Town of Trumbull, Connecticut

STONEHOUSE ROAD PAVEMENT REHABILITATION Trumbull, Connecticut

RFQ #5906 DUE: August 10, 2011 at 3:00PM

ADDENDUM # 1

BITUMINOUS CONCRETE DRIVEWAY RAMP

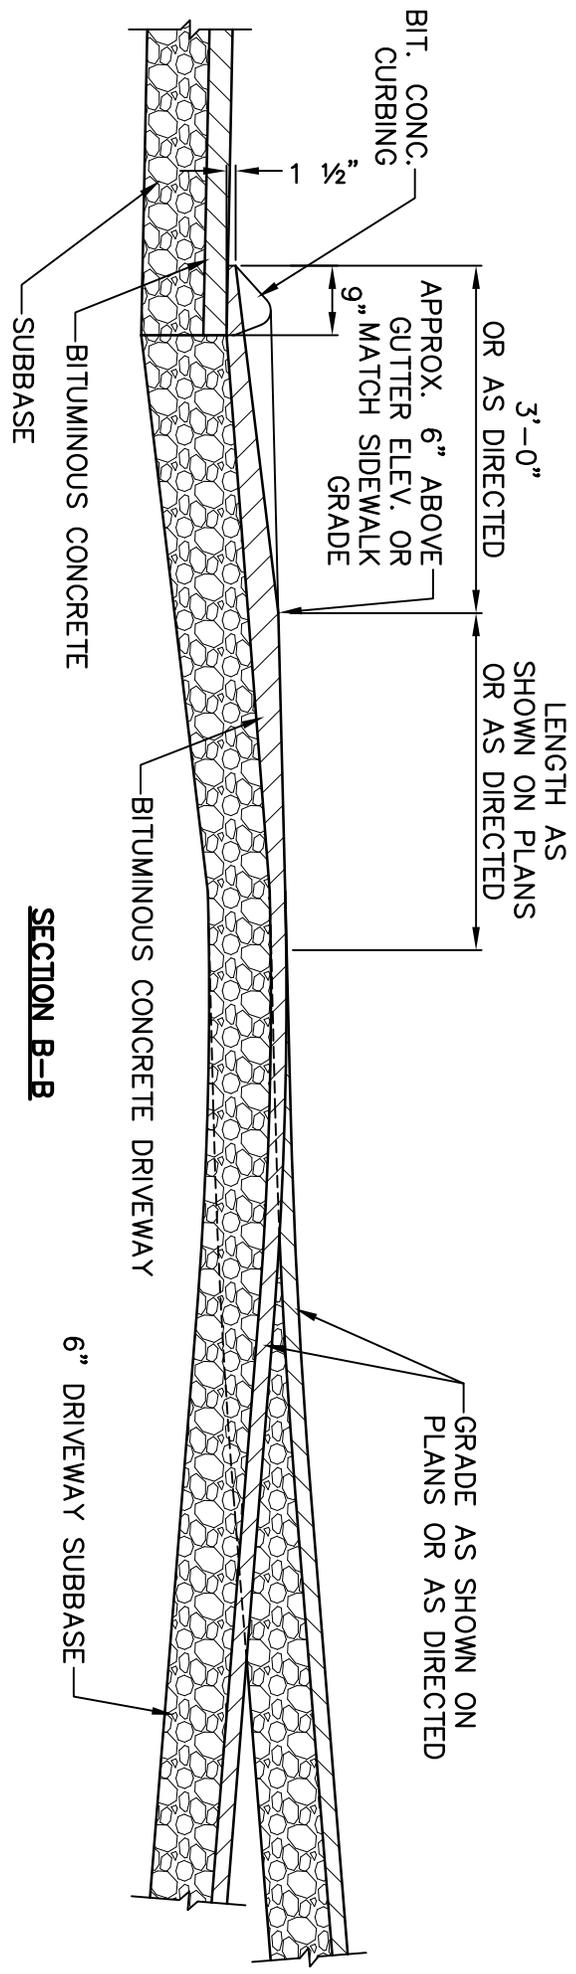
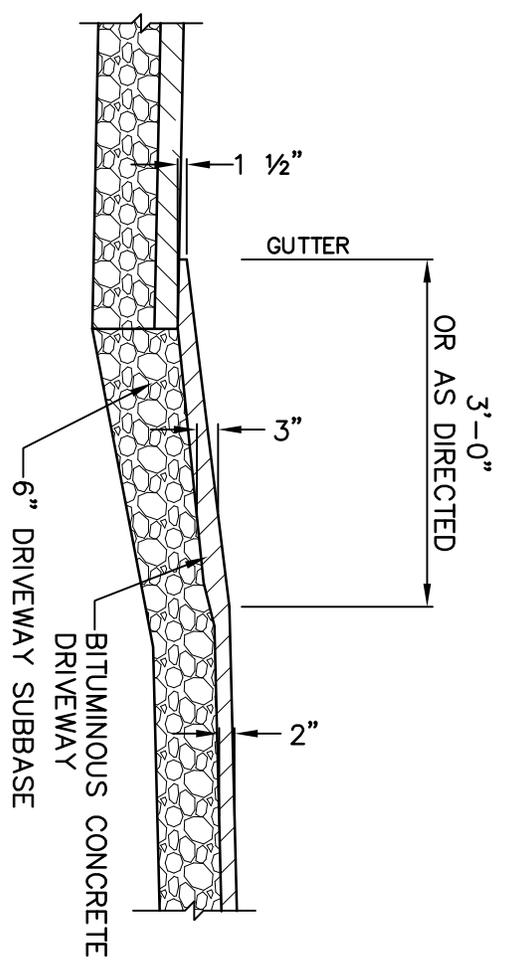
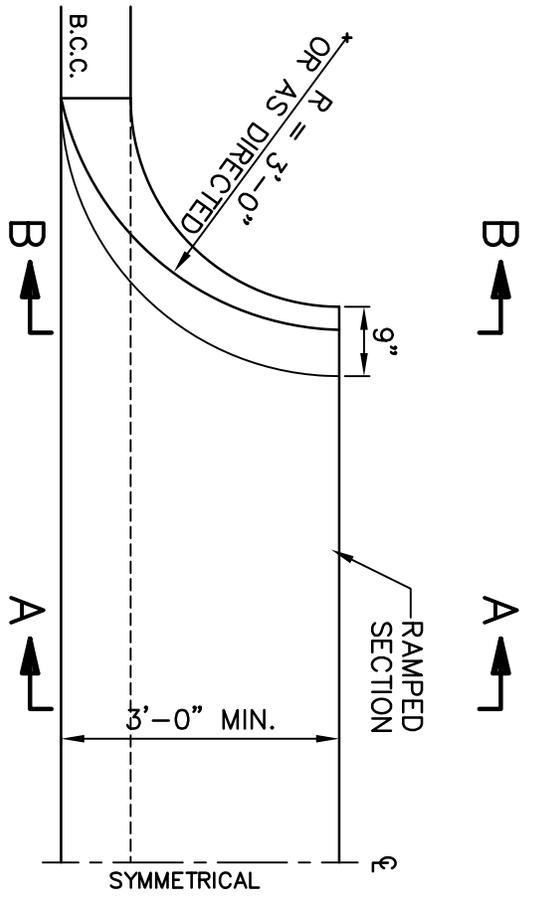
7. *Plans indicate to Saw Cut Driveways at the Gutter Line, the edge of the Reclaimed Pavement. This technique does not provide a proper seal between the Driveway and the New Road Pavement, which will allow surface water to penetrate the asphalt resulting in break back over time. Should reconstruction of the Driveway Aprons be added to the Scope of Work of this Project?*

Existing driveways are to be saw cut 3' up the driveway from the gutter line and reconstructed rather than saw cut at the gutter line as shown in the Bid Documents. See the revised Bid Proposal Form for this new Pay Item and see the attached detail “Bituminous Concrete Driveway Ramp.”

DETAILED ESTIMATE PLAN, NOTES, & DETAILS
SCALE: AS NOTED
C1.0

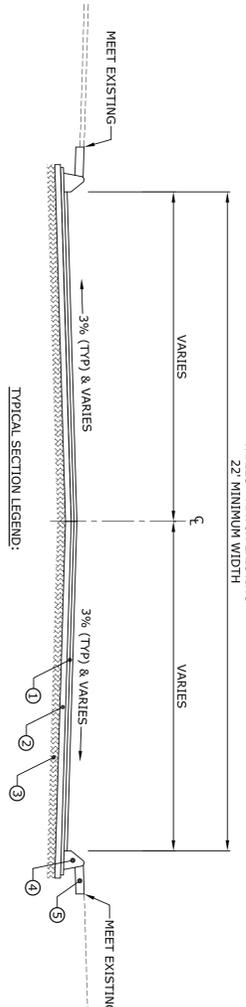
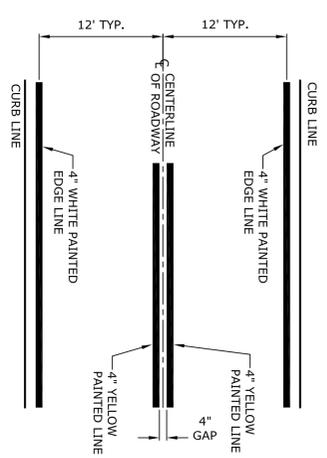
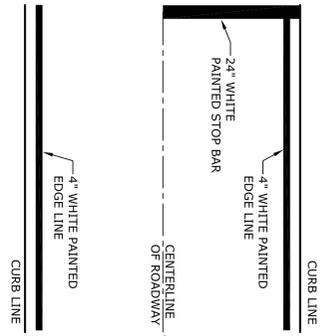
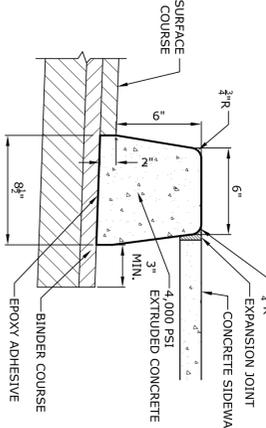
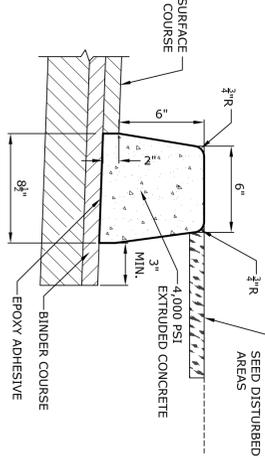
Item 1-3 Drawing C1.0, Detailed Estimate Plan, Notes and Details

Add pay items "0406999A – Asphalt Adjustment Cost, Per Est." and "0922501 – Bituminous Concrete Driveway, Per SY, Quantity = 750 SY.
